BLT and BLZP in pitch 5.0x – Addition of a screw locking

1. General Overview

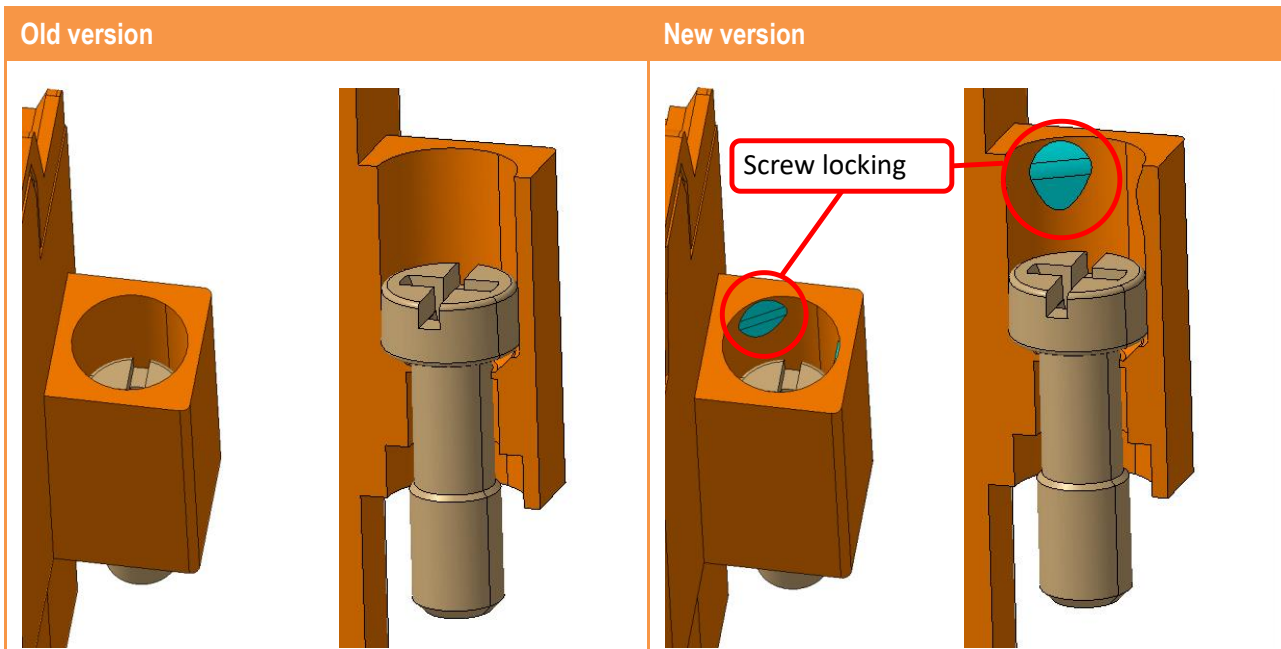
Due to a product adjustment and an associated quality improvement, the screw flange versions of the BLT and BLZP in 5.0x pitch will be delivered with a new screw locking in future. This action is intended to secure the screw against falling out during transport or after unscrewing.
